1st Further Information

**Proposed Temporary Warehouse (excluding Dangerous Goods Godown) with Ancillary Facilities
and Associated Filling of Land for a Period of 3 Years in "Agriculture" Zone,
Various Lots in D.D. 107 and Adjoining Government Land, Kam Tin, Yuen Long, New Territories**

(S.16 Planning Application No. A/YL-KTN/1090)

Responses-to-Comments

DWG. TITLE
FILLING OF LAND AREA

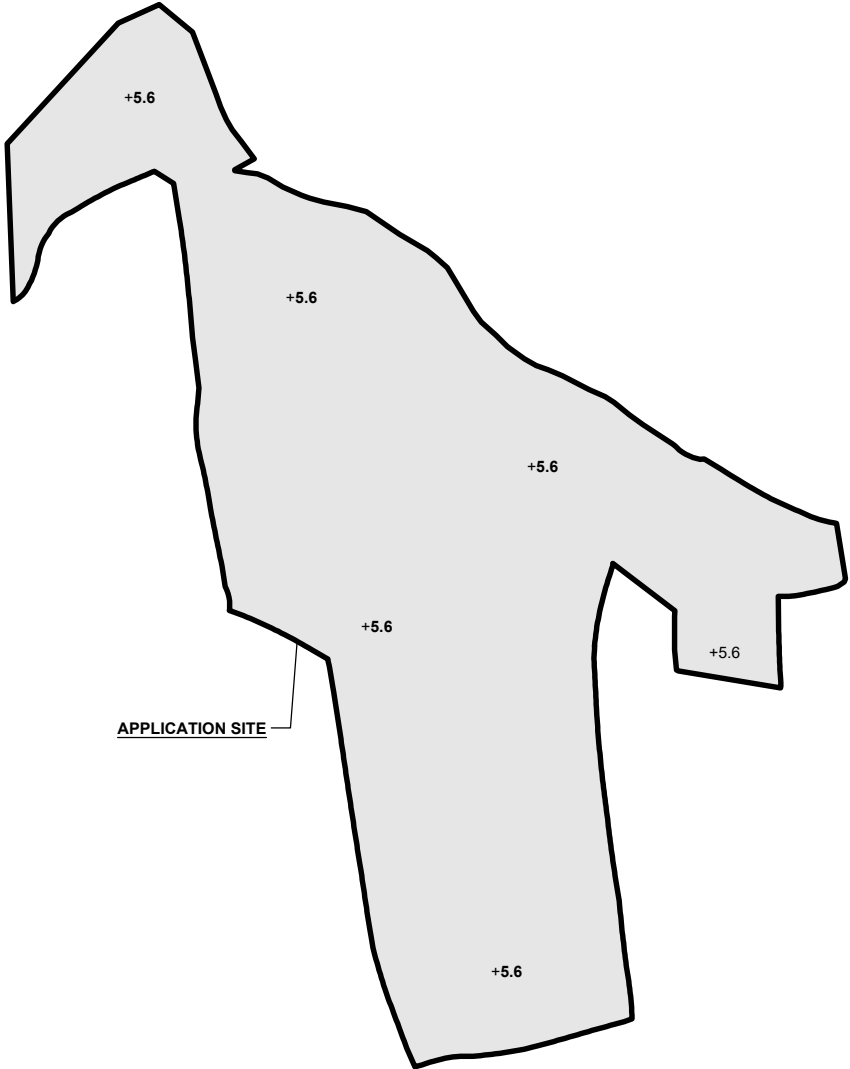
- The majority of the Site (i.e. 5,408m², 95% of the Site) has been filled with concrete with a site level of +5.4mPD. The current application serves to regularise the filled area to facilitate the proposed development. Upon obtaining planning approval from the Town Planning Board (the Board), further filling of land with concrete for not more than 0.4m (about) in depth is proposed to be carried out within the entire Site (**Plan 1** and **Annex I**). The proposed filling of land is intended to facilitate a flat surface to meet operational needs and smooth vehicle run-in/out. The applicant will strictly follow the proposed scheme, and no further filling of land will be carried out.

(f)	Please advise if any site formation/ land filling works to be carried out under this application. Please note that the overland flow from the adjacent lands should not be affected. Drainage facilities at lower platform should be provided.
